PLANNING AND ZONING BOARD MEETING

City Hall – Council Chamber
405 Bagshaw Way, Edgewood, Florida
Monday, August 08, 2022 at 6:30 PM

TO: Planning and Zoning Board (P&Z)
XC: Sandy Riffle, Interim City Clerk
 Brett Sollazzo, Administrative Assistant
 Drew Smith, City Attorney
 Allen C. Lane, Jr., P.E., CPH Engineering
FROM: Ellen Hardgrove, AICP, City Planning Consultant
DATE: July 29, 2022
SUBJECT: Tennis Court Variance at 510 Gatlin Avenue

Date: July 27, 2022
To: Planning and Zoning Board (P&Z)
From: Ellen Hardgrove, City Planning Consultant
XC: Sandy Riffle, Interim City Clerk
Brett Sollazzo, Administrative Assistant
Drew Smith, City Attorney
Allen Lane, City Engineering Consultant
Re: ECD Waivers Related to Proposed Car Wash at 4800 South Orange Avenue.

Exhibit 2 – Tennis Court Location

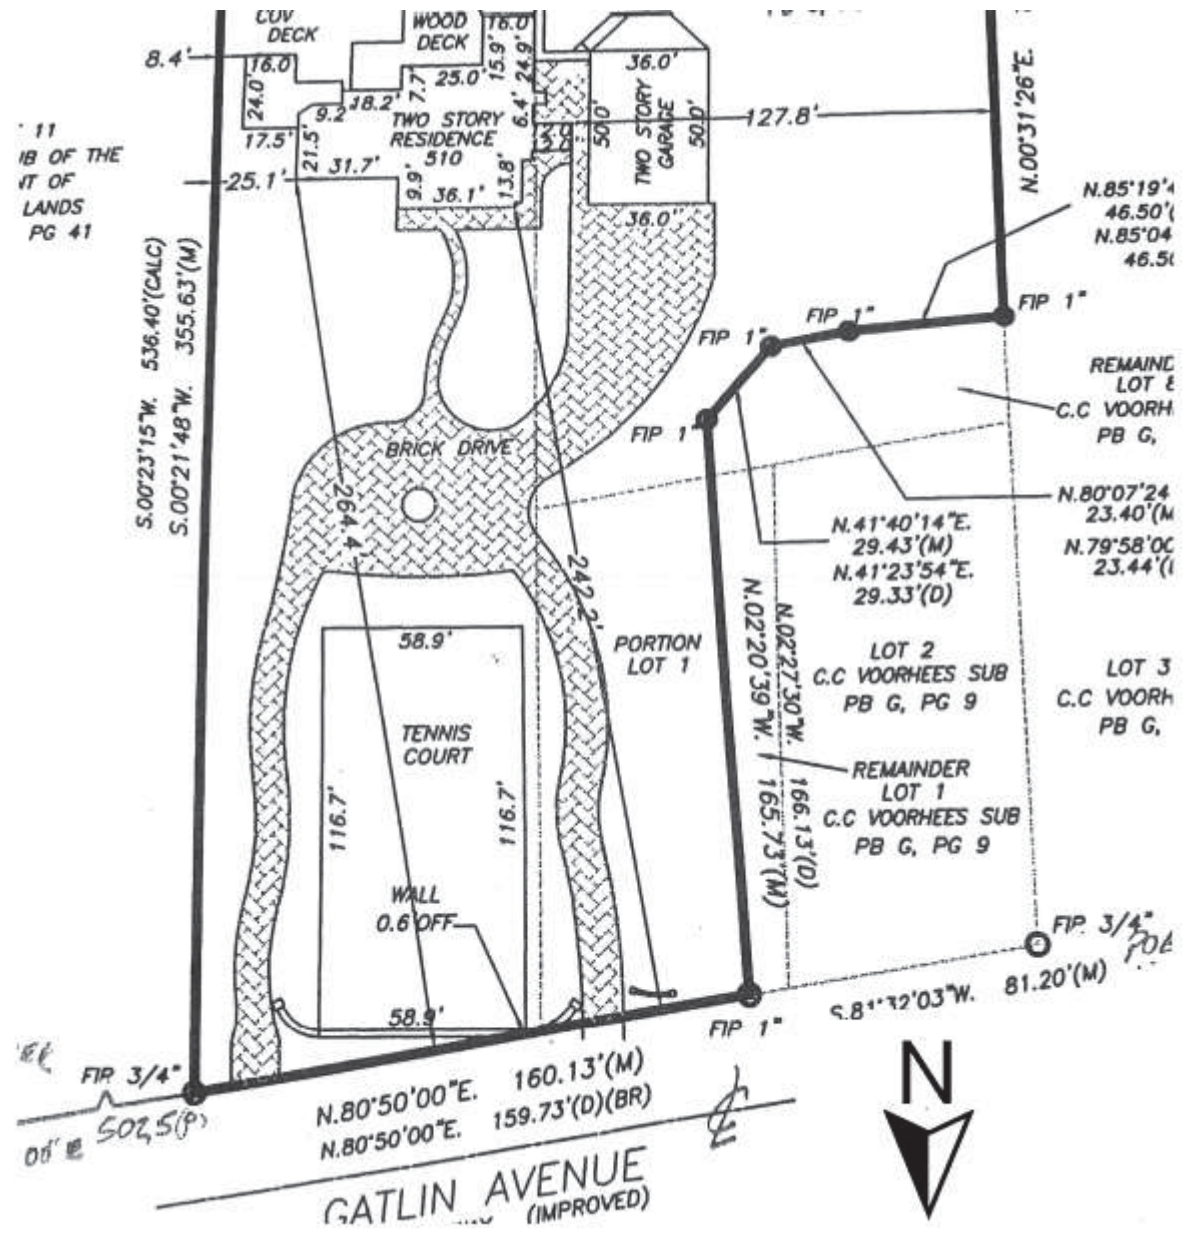
The existing fence varies from four (4) to ten (10) feet, with most of the segments in the front setback eight (8) feet, exceeding the maximum permitted in the front setback: four (4) feet per Code Section 134-517. The portions exceeding four feet in the front setback are viewed as legally nonconforming. As a note, the existing tennis court is also viewed as a legal nonconformity as an accessory use is not allowed in front of the principal building.

Code Section 134-38 (Nonconforming uses) allows nonconformities to continue, but does not encourage their survival. Replacement requires conformance with code; i.e., maximum four feet in height in the north 25± feet of the court.

Exhibit 3 – Proposed Car Wash Layout

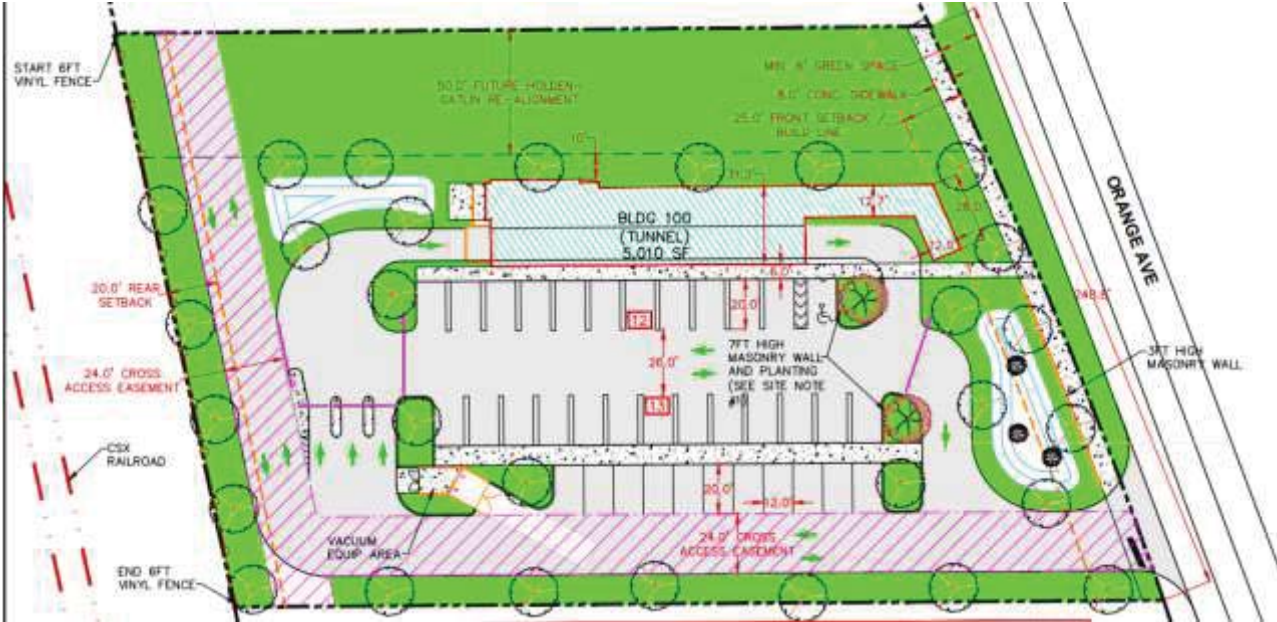
The primary waiver requested is to allow the building to only face 11.25% of the Orange Avenue frontage (28 feet building frontage with 248.8 feet lot width) instead of the required 70% (Code Section 134-468(f)) in order to help achieve the City’s goal to provide a solution to the traffic issues created by Holden/Orange/Gatlin Avenues offset intersections. As shown in Exhibit 3, with use of the waiver, the applicant is proposing to reserve the north 50 feet of the property for future acquisition to accommodate a conceptual Holden/Gatlin Avenue realignment known as Orange County’s Intersection Analysis Study Alternative 1, which is shown in Exhibit 4.

Exhibit 5 – Proposed Vacuum Screen Wall Locations

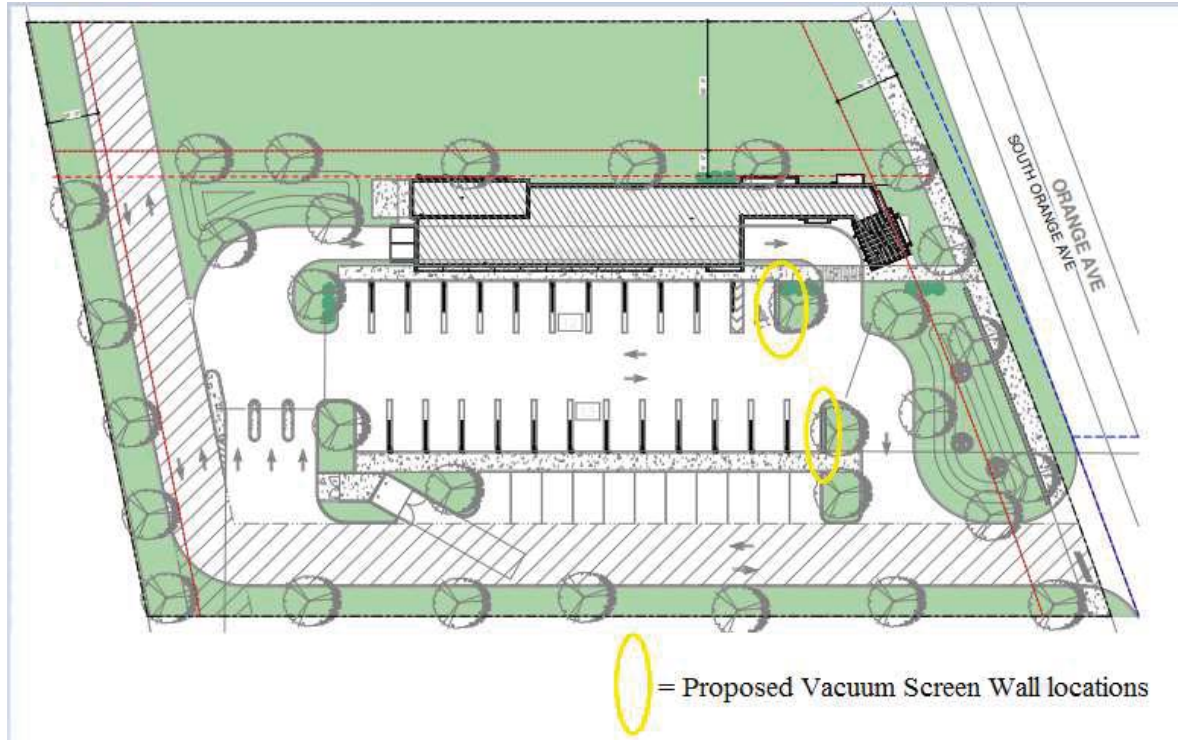
- The applicant is requesting a waiver to allow the vacuum stations to be screened from Orange Avenue with an alternate design than that required by Code Section 134-472(a)(4). The applicant is proposing a 7 feet high masonry stucco wall matching the colors of the building at the east end of each row of vacuum parking stalls as shown in Exhibit 5. ECD design standards require those walls to be consistent with ECD front elevation standards, such as, but limited to window transparency and avoidance of blank walls. The applicant justifies the need for this waiver as a consequence to turning the building in order to preserve the northern 50 feet for the Holden Avenue realignment.

A magnolia tree, 3 inch caliper/12 feet high at planting, is proposed to be placed in front of each wall along with a hedge along the entire length. It should be noted that the City’s Landscape Architect has concerns related to the viability of the hedges in this location: the hedges will not receive enough sunlight with a wall blocking all the afternoon sun and magnolia trees blocking most of the morning sun.

- The applicant is requesting a waiver to allow the vacuum stations to be screened from adjacent Low Density Residential Future Land Use (LDR FLU) designated land (west property line) with a six feet high beige vinyl fence instead of a seven (7) feet high opaque brick wall as required by Code Section 134-472(a)(4). The applicant’s justification for this screen waiver is that the adjacent land is the railroad and then Cypress Grove Park, not residential used land.

The required ECD brick wall was contemplated in this location even with the presence of the railroad tracks and park. It should be noted that this wall is required for all ECD development adjacent to Low Density Residential Development, not just to screen the vacuum stations. Deviation from this ECD design standard in this location should be viewed as a policy change that would be applied in other locations adjacent to the railroad track and park.

A second justification for this waiver is a fence would be easier to remove if the land eventually became the Holden Avenue alignment. As stated above the County’s conceptual design for the realignment is the northern 100+ feet, while the applicant is requesting the less permanent screen (fence vs wall) along the entire perimeter.

Exhibit 3 – Proposed Subdivision

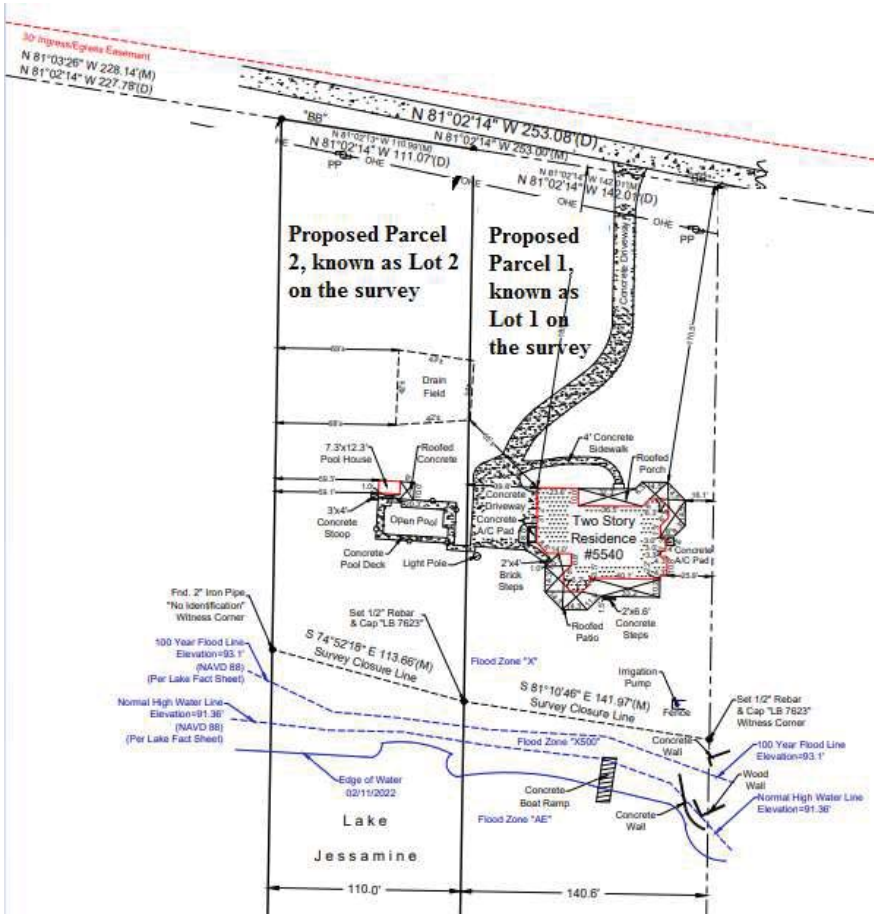
Code Section 126-61 provides an exemption to the full subdivision review process when no new streets, water, sewer or drainage structures are involved, known as a Parcel Split. The proposed subdivision qualifies for this exemption; as such, preliminary and final subdivision plans (the plat) are not necessary.
